Arlington – DPW Facility
WSE Project No. 2170997

**Re: *Environmental Design Review
Arlington Municipal Facility
49 and 51 Grove Street***

On behalf of the Town of Arlington, Weston & Sampson Engineers, Inc. is hereby enclosing supplemental information for the above project in response to the comments received at the February 22, 2021 Arlington Redevelopment Board meeting. Below is a summary of the questions raised at the meeting with the associated responses. Support documentation has been attached to this letter to supplement the responses below.

Front Elevation, Building Signage

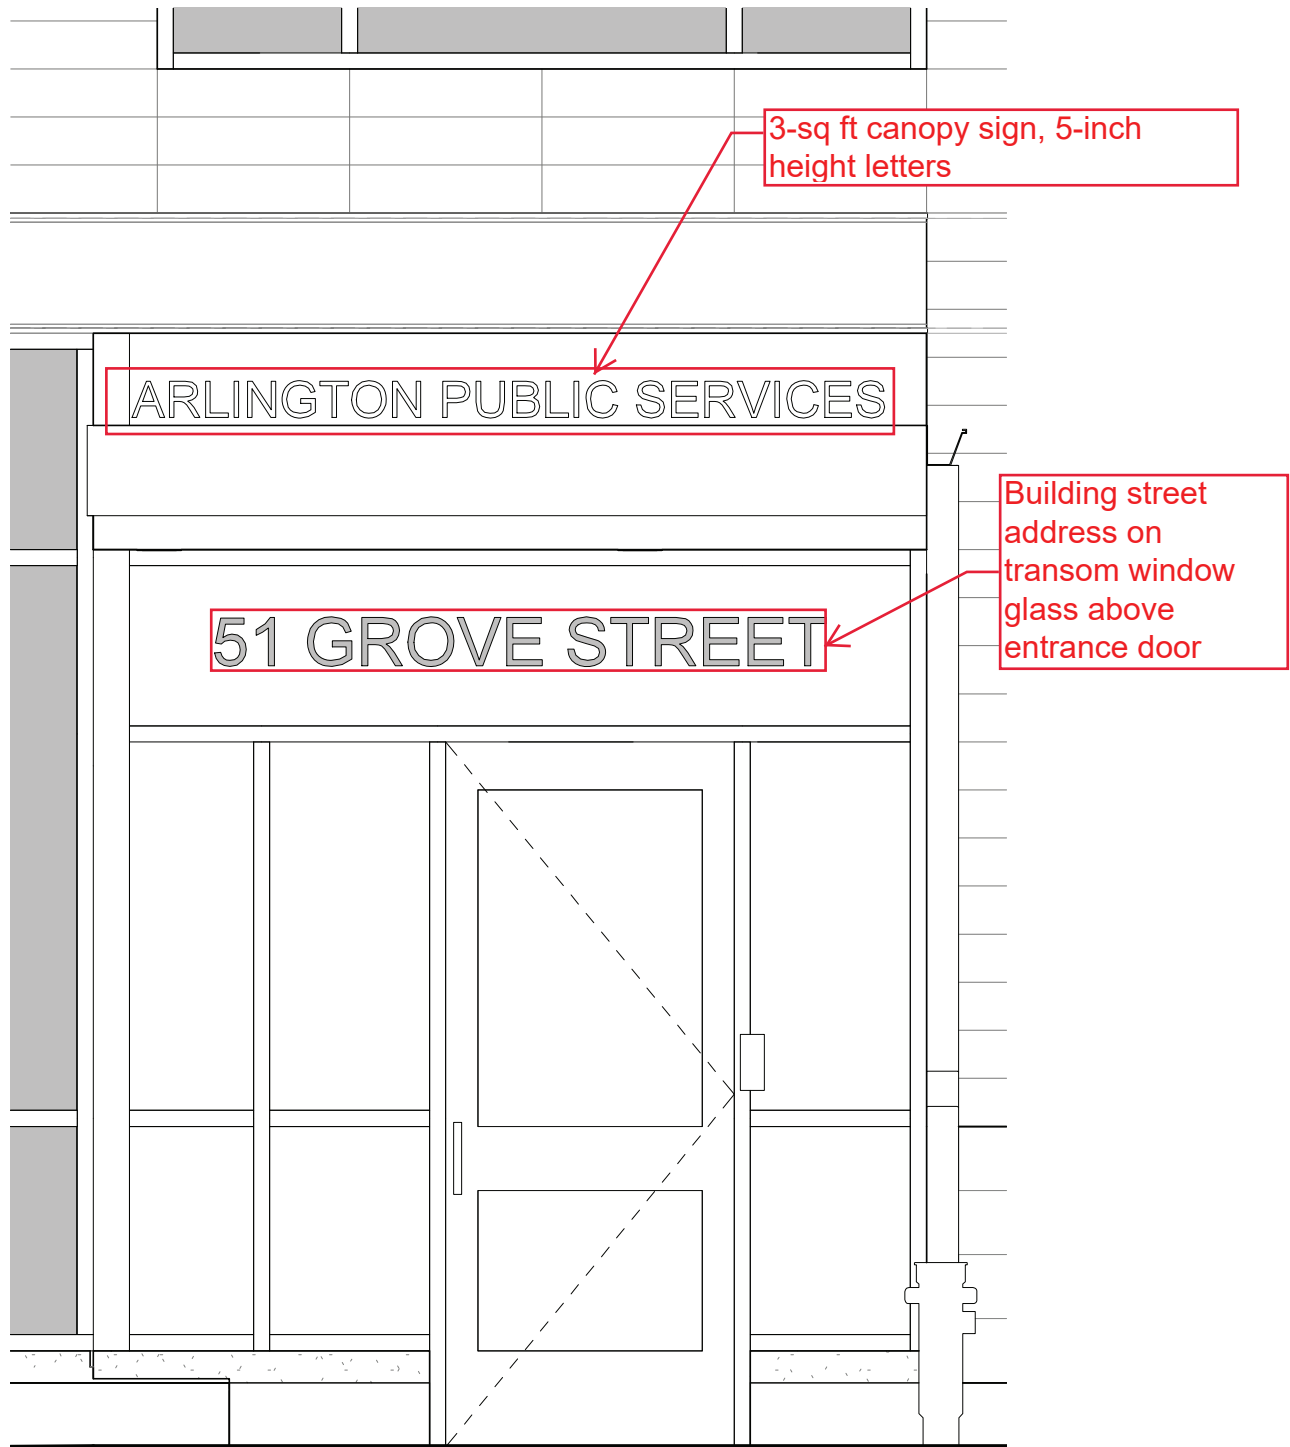
Comment 4: The ARB requested that additional details related to the proposed signage be provided demonstrating compliance with the Zoning Bylaws.

Complies with Arlington Zoning Bylaw Sections 6-34, 6-35:

- 1. One wall sign, as permitted**
- 2. Height of sign is 10-ft, in compliance with 25-ft maximum height requirement**
- 3. Sign area is 17-sq ft, in compliance with maximum 40-sq ft area requirement**
- 4. Sign width is 4'-9", positioned within 8-ft width building element, in compliance with 60% maximum width sign coverage of building section.**

Town of Arlington
Town Yard Facility - Building E
Front Elevation

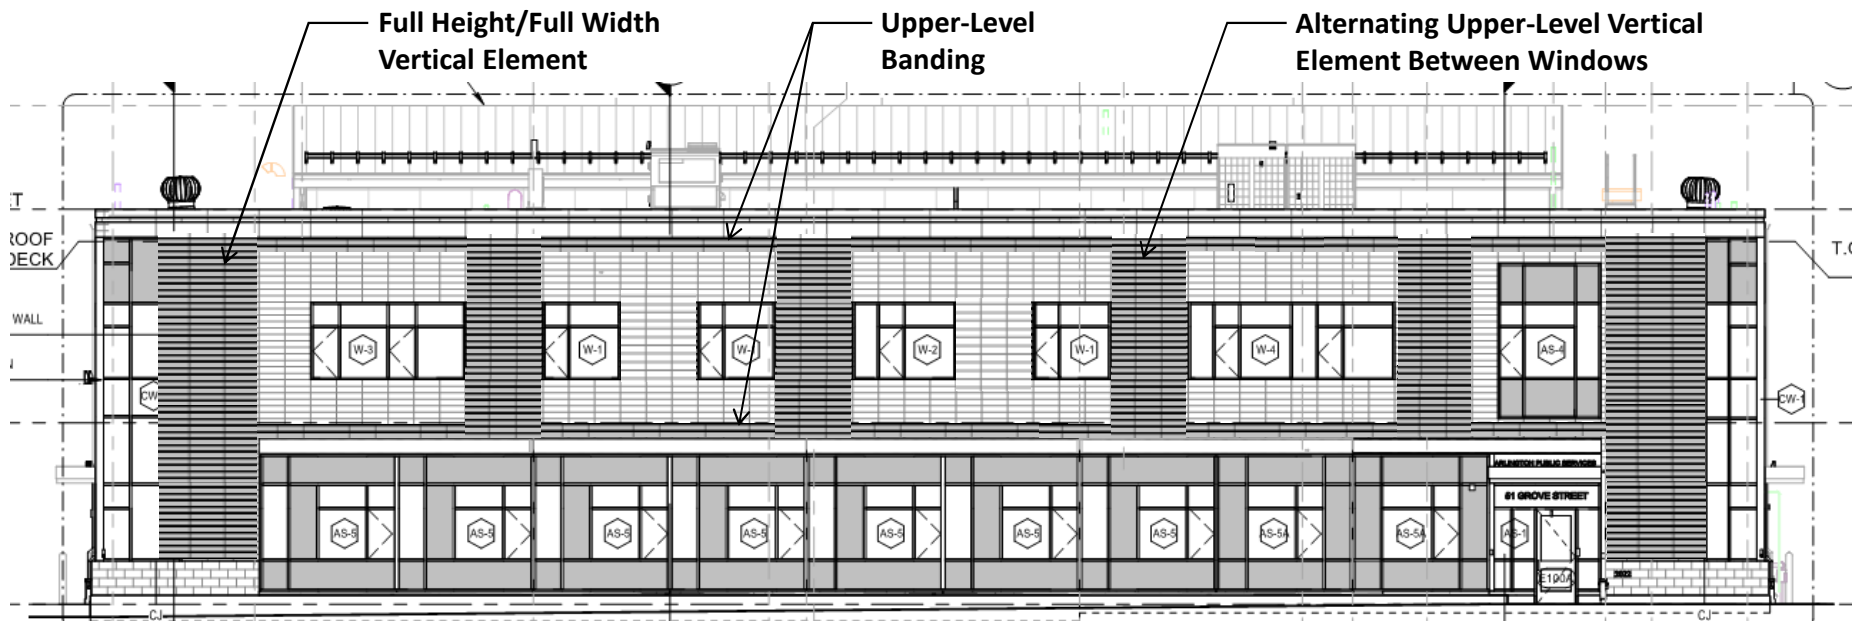
Comment 5: The ARB provided some feedback related to the aesthetics of Building E. The ARB requested that Weston & Sampson evaluate alternatives to assist in breaking up the massing using features that could potentially create vertical bays along the façade.

- Introduction of alternating vertical elements at upper-level between windows using alternate material profile and/or color
- Introduction of full height / full width vertical elements using alternate material profile and/or color at entrance towers
- Banding on upper level using alternate material profile and/or color to further accentuate bay pattern
